Field campaign

Topic	Tonneau micro switch – mounting bush orientation (SC14/21)
Market area	Bentley: worldwide (2WBE)
Brand	Bentley
Transaction No.	2037971/1
Campaign number	EA21
Note	
Type	Workshop campaign
US code

New Continental GT Convertible

Figure 1

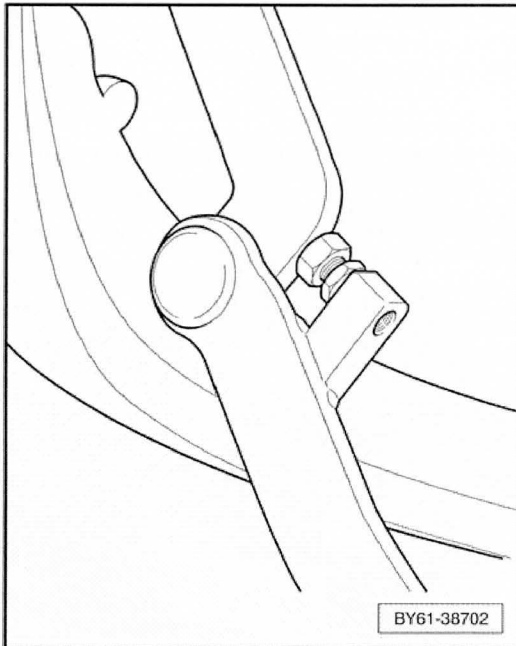
1. With the ignition on, partially raise the power operated roof until the tonneau cover is held in the vertical position and secured against the lock stops on the hinge mechanism (see Figure 1)

Figure 4

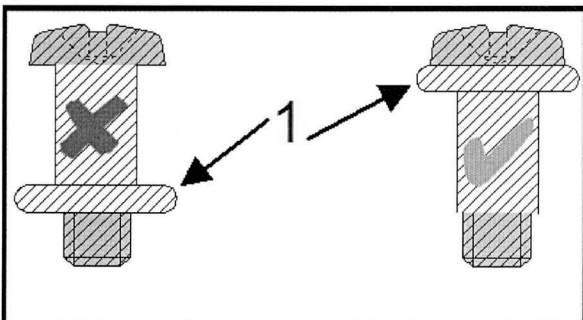
4. If the 'top hat' bush (1) figure 4 is correctly oriented then apply a blue campaign completion mark to the switch housing no further work is required (see Figure 5). If the housing is found to contain and incorrectly orientated bush then replace the switch assembly (part number 3W7953229A) Rep Gr 61 Tonneau cover hinge microswitch – To remove, fit and set

Figure 5

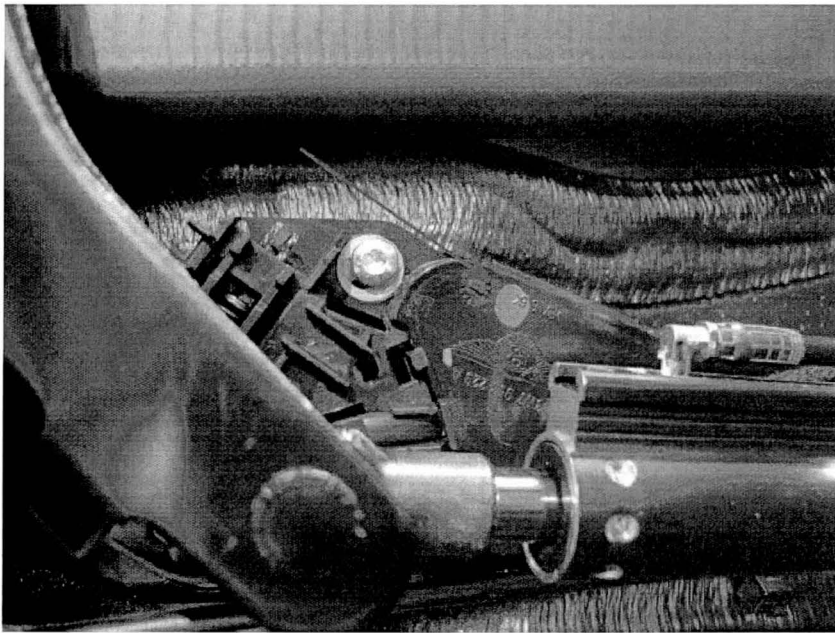
On completion apply a blue campaign completion mark to the switch housing (see Figure 5)
